Figure 14. Input and Output Ripple in PSM Mode

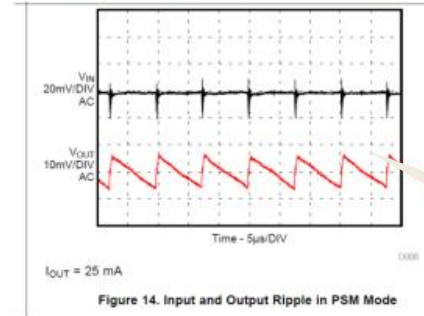
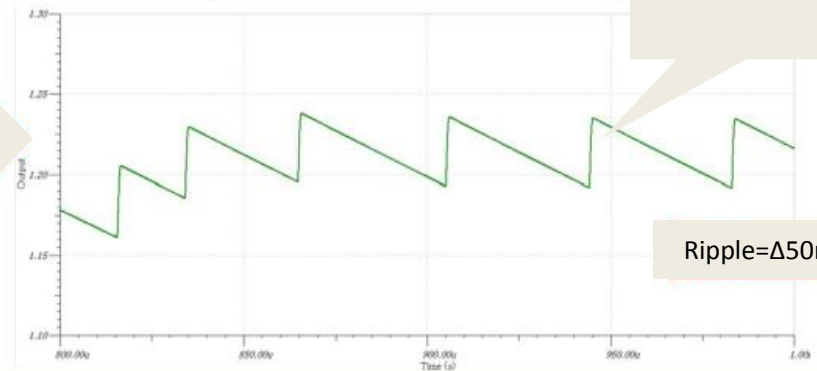
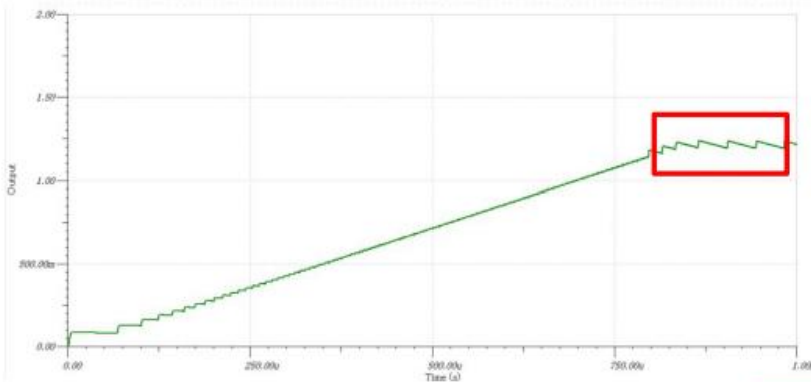
Ripple=Δ15mV

It is different ripple level

Ripple=Δ50mV

A simulation under the same conditions as the data sheet.
Customers want to know why the ripple level different.
